Access Compliance Report

Public Rights-of-Way

Intersection ID: 31905	Main Street: PALOMAR_MOUNTAIN_DR	Cross Street: STOWE_DERBY_DR	Location: NW
ADA ID: 457791E86B0F	Ramp Type: BlendTrans1	Initial Pass/Fail: Fail	Overall Compliance: No
		Severity Score: 10

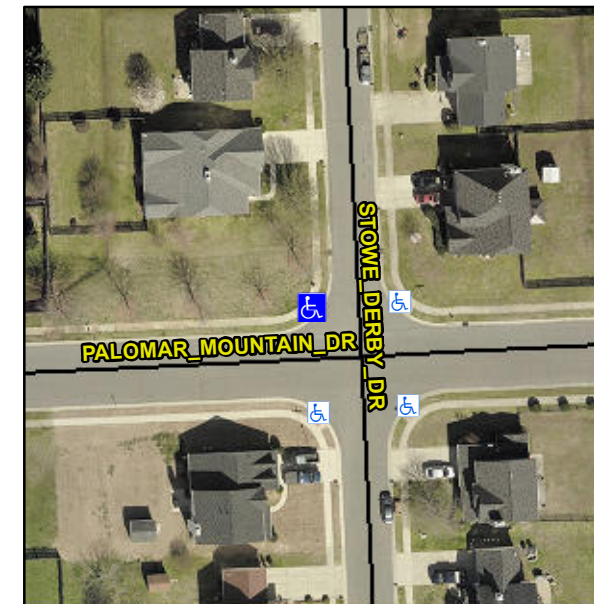
Not Found, R304.5.1, R304.5.3

Compliance	Description	Data	Compliance	Description	Data
N/A	Ramp Length (in)	49.0	Yes	BlendTrans Slope (%)	4.7
No	Ramp Width (in)	37.5	No	BlendTrans XSlope (%)	2.6
N/A	Flare Type LT	N/A	N/A	Flare Type RT	N/A
N/A	Flare Slope LT (%)	N/A	N/A	Flare Slope RT (%)	N/A
N/A	Flare Traversable LT?	N/A	N/A	Flare Traversable RT?	N/A
N/A	Landing Length (in)	N/A	N/A	DWS Provided?	N/A
N/A	Landing Width (in)	N/A	N/A	DWS Contrast?	N/A
N/A	Landing Slope (%)	N/A	N/A	DWS Length (in)	N/A
N/A	Landing X Slope (%)	N/A	N/A	DWS Full Width?	N/A
N/A	Landing Curb? (Y/N)	N/A	N/A	DWS Offset (in)	N/A
N/A	Shared Landing?	N/A			
N/A	Gutter Ponding?	N/A	N/A	Gutter Slope (%)	N/A
N/A	Gutter Lip Ht (in)	N/A	N/A	Gutter X Slope (%)	N/A
N/A	Painted X Walk1?	No	N/A	Painted X Walk2?	No
	X Walk 1 Direction	To S		X Walk 2 Direction	To E
	X Walk 1 Width (in)	N/A		X Walk 2 Width (in)	N/A
	X Walk 1 Slope (%)	2.8		X Walk 2 Slope (%)	1.6
	X Walk 1 X Slope (%)	0.3		X Walk 2 X Slope (%)	1.8

Remove & Replace Curb Ramp With Two New Directional Ramps or Equivalent.
